4.2.2 WORKING WITH THE WIDER CAMPUS

4.2.3. PLANNING APPLICATION & ODRP ENGAGEMENT

Extensive engagement with Oxford local planning authority, University stakeholders, members of the public and a review with the Oxford Independent Design Review Panel has informed the development of the submitted landscape design. A summary of initiatives has been outlined in response to recommendations raised during these forums:

Slide from pre-application meeting mapping spatial functionality.

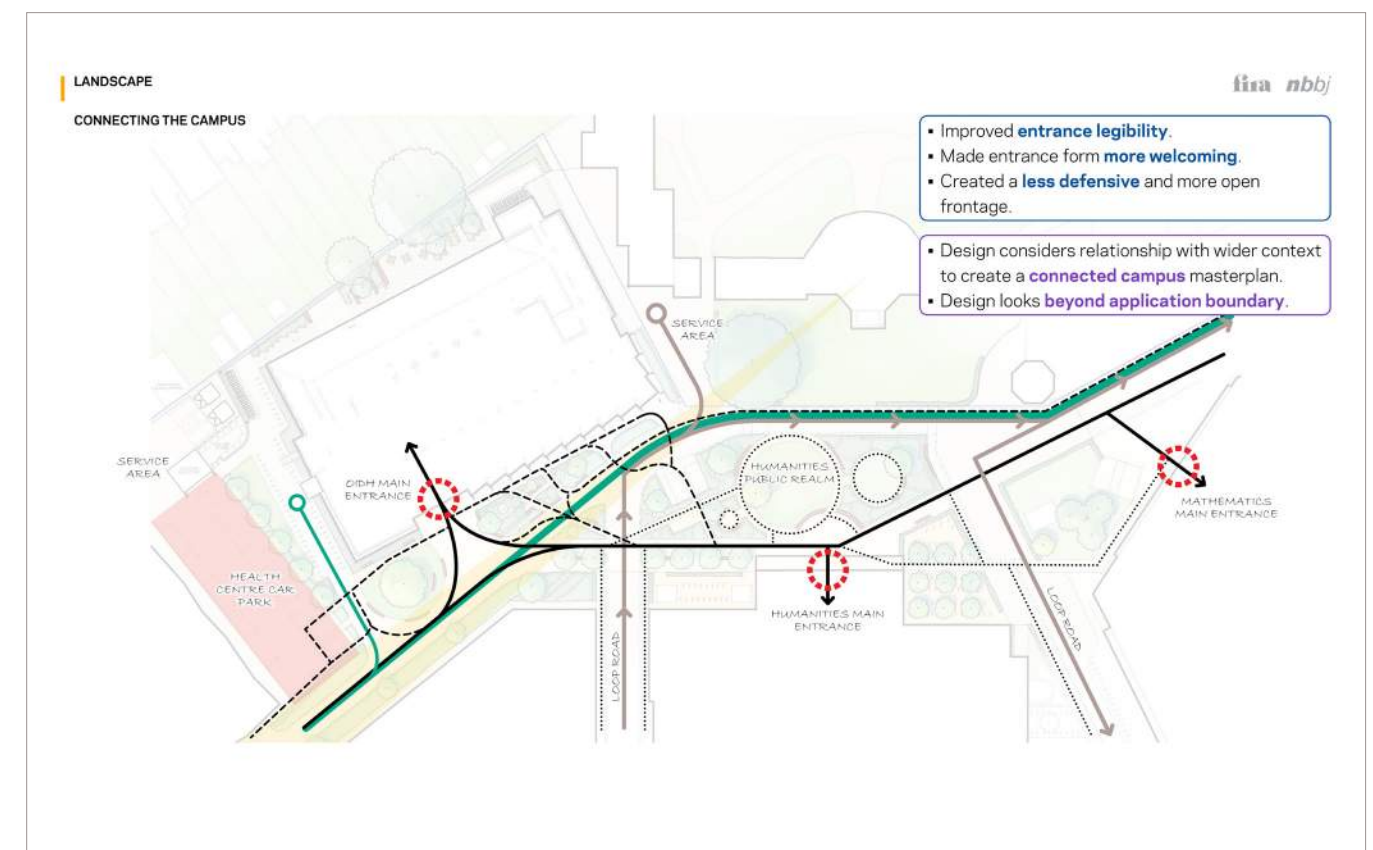
**'The retention of the building creates a triangular pocket of open space to the front of the Institute which lacks a clear function or identity associated with digital health. It also feels defensive because of the orthogonal hedges, the hard edge, and the location of the disabled parking. Addressing these issues would make this space more welcoming, and the addition of benches would help to signal that this south facing garden is an area to walk into and spend time in.'** (ODRP feedback - november 2023).

**'A study should be carried out to define how people move through the open space between the building and the street, where people sit, and which areas provide some privacy.'** (ODRP feedback - november 2023).

**'The character of this space should be sufficiently distinct so that someone meeting a friend or colleague who has not visited before can suggest a recognisable meeting place.'** (ODRP feedback - November 2023)

**'The walled garden to the rear of the Institute lacks a distinct character. The principle of reusing this space and providing a shaded area is positive, but the planting conceals the important historic wall rather than celebrating it. The character of this space should be more clearly differentiated from the open space to the front and that of the courtyard. Movement from the entrance to the rear garden, with views of the exposed wall, should celebrate the combination of new and old, and this juxtaposition should inform the character of the garden itself.'** (ODRP feedback - November 2023).

Entrance legibility has been enhanced through use of hard and soft landscape to establish a well defined entry point. A range of street furniture and amenity features have been proposed at the entrance to create a welcoming environment and

make the frontage more open and publicly focused.

Contrasting spaces have been defined through use of planting, edges and changes in scale.

A prominent parkland tree has been used to define a memorable 'meeting point' and assist with way-finding.

The walled garden (to the site rear) has been given a distinct and contrasting character, derived from the character of the boundary wall.

Slide from pre-application meeting illustrating vehicular movement.

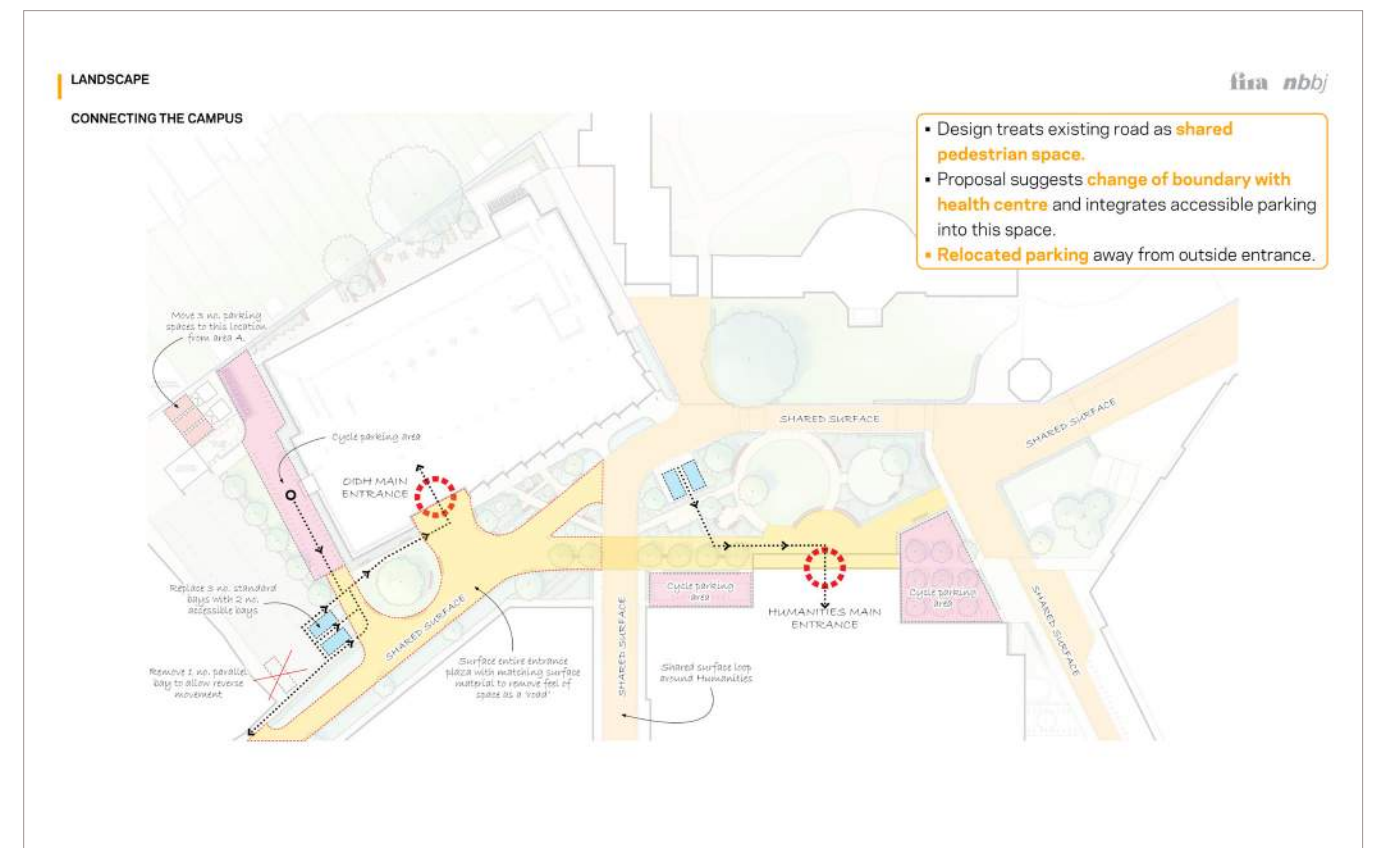
**'This collaborative work will also help to address issues like the 'road' that passes in front of the Institute. This should be integrated within the wider public realm as a space for pedestrians and cyclists to use, with only occasional vehicular use. It should be a shared surface using materials suited to walking and likely to slow traffic. If kerbs are required, these should be lowered, and there should be no 'road' markings and minimal use of vehicular signage.'** (ODRP feedback - November 2023).

**'The south-west corner of the site is compromised by the location of the car and cycle parking. As part of the development of a holistic, collaborative approach to the public realm, we suggest negotiating a change in the boundary line between the Institute and New Radcliffe House to increase the width and efficiency of the existing New Radcliffe House car park so that the parking for the Institute can be accommodated.'** (ODRP feedback - November 2023).

**'The disabled parking located next to the entrance to the Institute should be relocated away from the front entrance to this shared car park.'** (ODRP feedback - November 2023).

The street space to the site entrance is to be treated as a shared space, prioritising pedestrians and cyclists over vehicular use.

A negotiation with the adjacent leased Health Centre land has been considered, however this has been ruled out following solicitor advice.

Parking has been relocated as far away from the main entrance while still meeting building regulations.

Early entrance location and expression studies

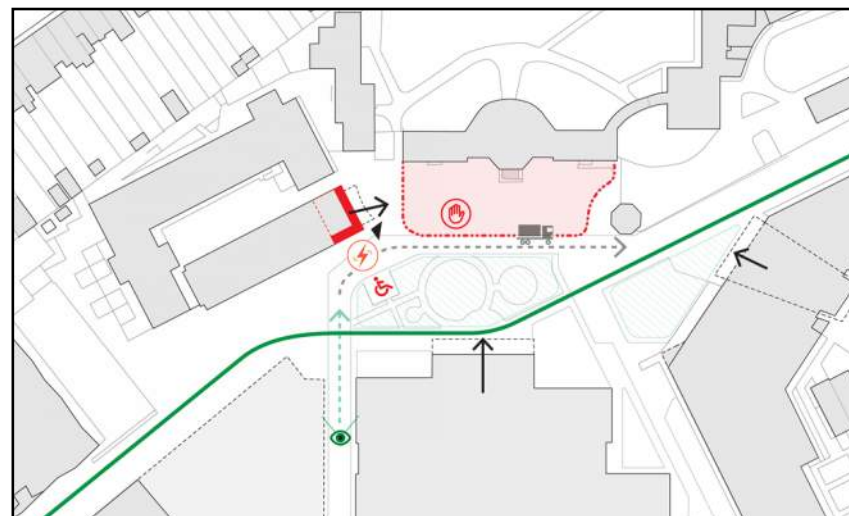
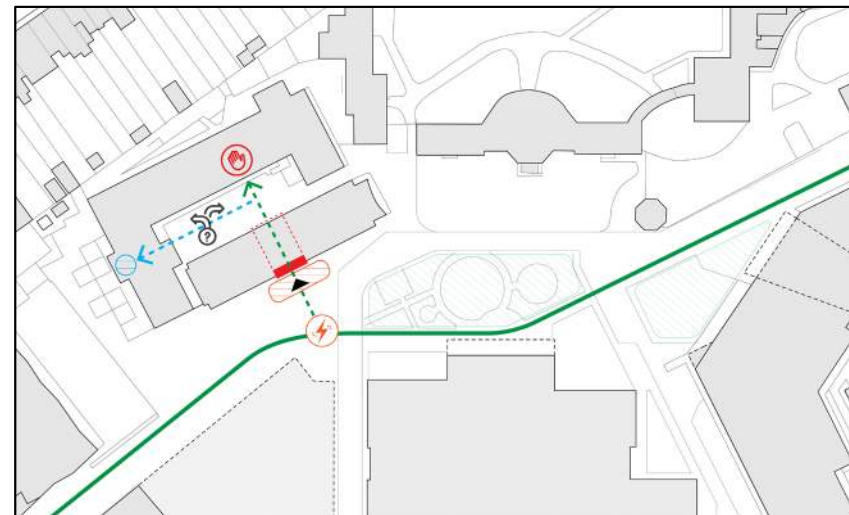
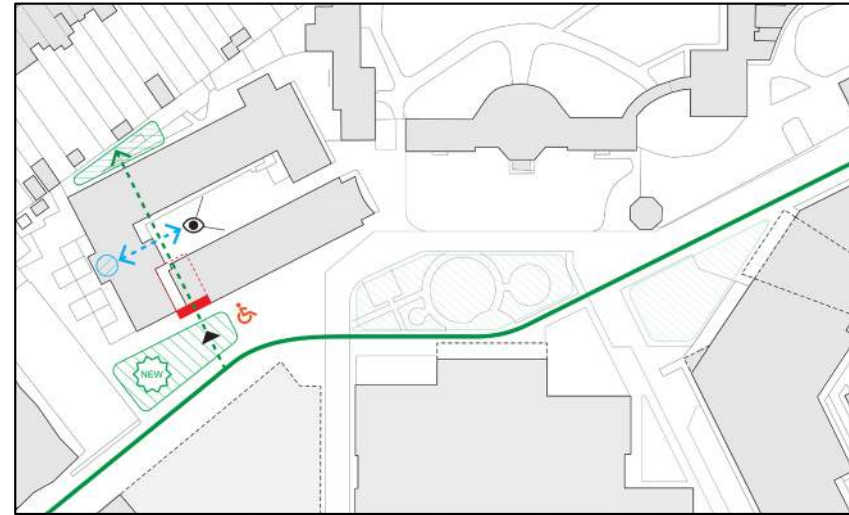
'OCC Noted the north-eastern corner of the building was a key node/hot spot with the Observatory, Humanities and the Information Sciences Building as well as main route through the site for pedestrians and cyclists. JN questioned the location of the main entrance at the other end of the block. The location of the entrance in relation to the Information Sciences Building and emerging street layout needs coordination and testing in local views.' (Feedback from Pre-app 01 - June 2023).

Given the setting of the building the team further explored the setting of the entrance in relation to the wider context. Three options included:

1. Between Harkness & Gibson (as existing)
2. Central
3. Radcliffe Observatory Corner.

Radcliffe Observatory and Humanities grab attention and proposed OIDH and Maths Building become a back drop

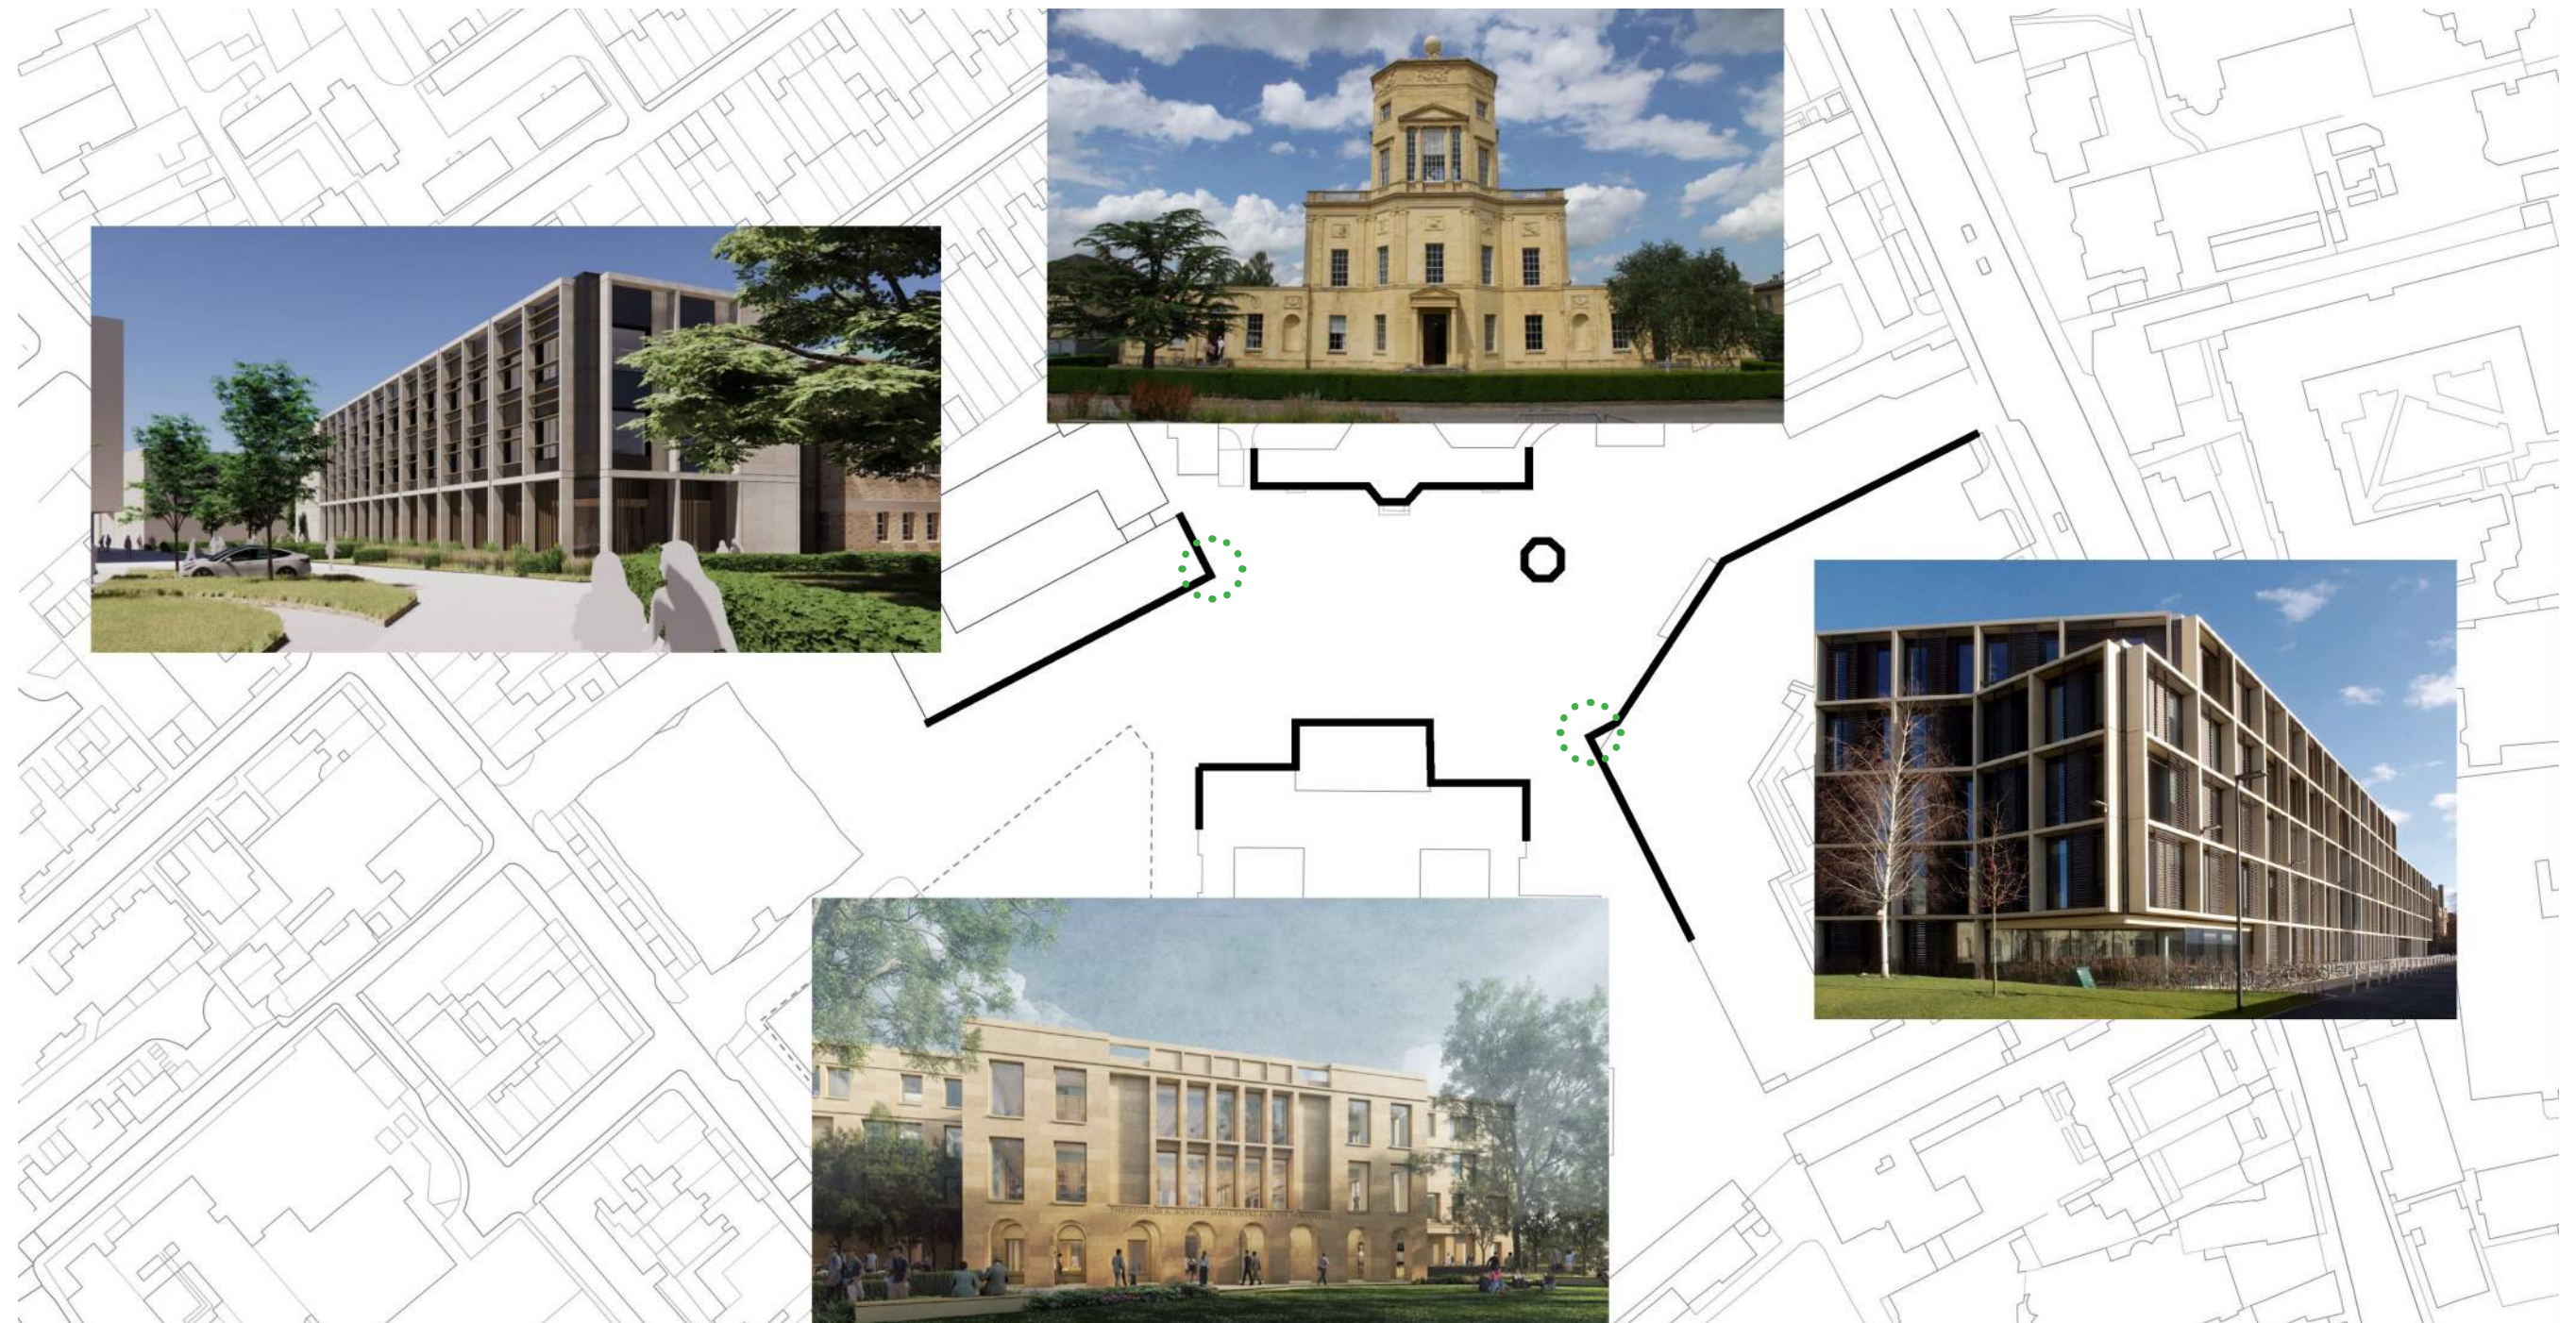
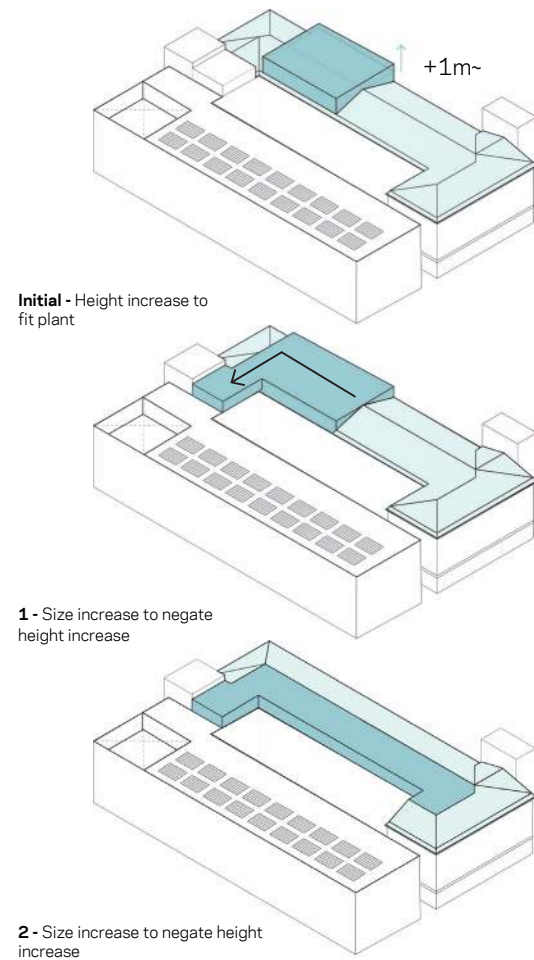
**'Does the building grab your attention or sit back and frame other buildings.'** (Feedback from Pre-app 02 - August 2023).

Given the significance of the site and the adjacent buildings the team were encouraged to decide and commit to whether the building would fight for attention or indeed sit as a backdrop to

Since the project's inception, the fundamental idea has been for the building to serve as a backdrop to the Observatory, carefully crafted to complement the surrounding context. Taking into account the proximity of the new humanities and Maths buildings, positioned adjacent to the Observatory, the design evolved to align with the site dynamics. The Humanities and Observatory, situated opposite each other, naturally emerged

as the focal buildings on the site, while the Maths and the new OIDH serve as contemporary backdrops. The architectural languages of both pairs seamlessly communicate, contributing to a unified visual experience.

By considering the corner studies completed in section 02, the proposal draws inspiration from the Andrew Wiles building and St Anthony's College open bookend corners to reduce the overall bulk minimising the impact on the Radcliffe Observatory.

1. Initial GF proposal

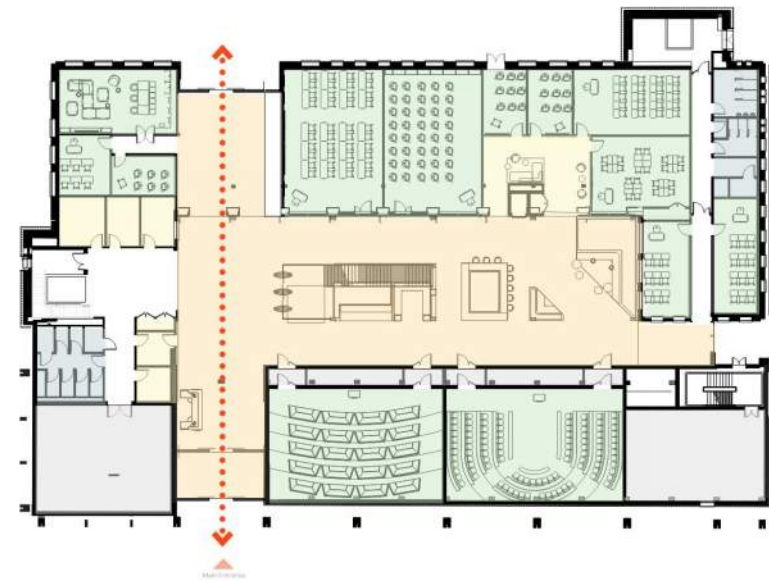
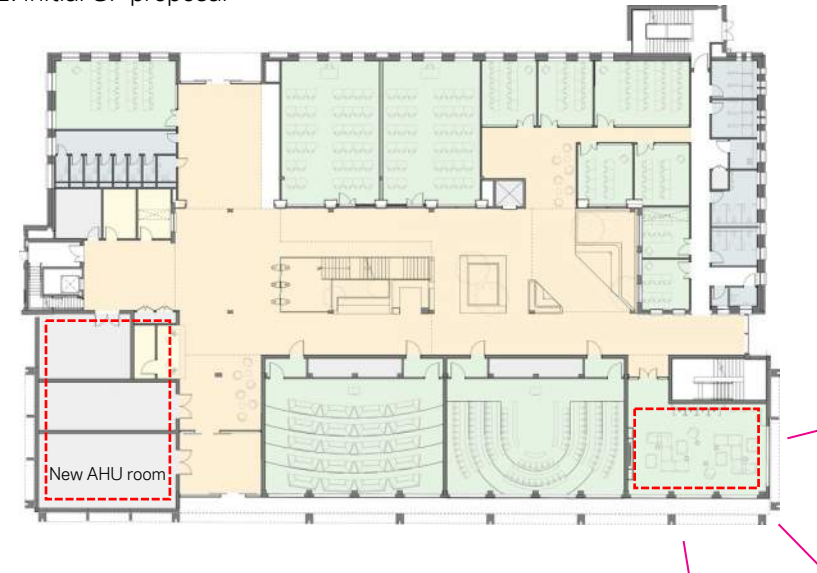
**'OCC raised concerns about the entrance location and south east corner of the building... - The south eastern corner at the end of a view is a prominent corner where we have said it would be best to pull back, now proposing plant room there so will have louvres etc, which raises concern. Don't feel previous advice has been digested. Would expect the plant room to be to the rear, not facing an active frontage.'** (Feedback from Pre-app 02 - October 2023).

**'Noted it is interesting to see how the frontage is activated by windows.'** (Feedback from Pre-app 02 - October 2023).

Although there haven't been significant changes to the ground floor layout, a notable evolution involves the relocation of the lecture theatre Air Handling Unit (AHU) plant room. Previously situated in the southeast corner, this plant room occupied a substantial portion of the building's GF at a particularly important corner, presenting challenges during the planning process. In response, the team explored options to move the room to the new southwest plant tower, necessitating the northward relocation of the WC and amenity space to create room for the shift.

This relocation of the plant space has, in turn, freed up space in the east corner (adjacent to the Radcliffe Observatory and the new humanities plot), proving beneficial for enhancing the building's relationship with the external campus. By moving a larger teaching space to this area, the concept of activating the ground floor from the outside has been strengthened, making education visible from the street.

A significant enhancement to the ground floor occurred with the transformation of the south facade. Initially proposed as a reglit semi-transparent glazing system, it evolved in response to the client's desire to activate the ground floor and showcase the activities within. The design progressed to feature glazed units within a solid wall, enabling the lecture halls and new multi-functional space to be visible from the outside. To infuse dynamism into the facade and establish a stronger relationship with the surroundings, a sawtooth design was integrated, aligning with the observatory axis. This allowed for the introduction of solid elements in the shorter face, reducing the glazing ratio.
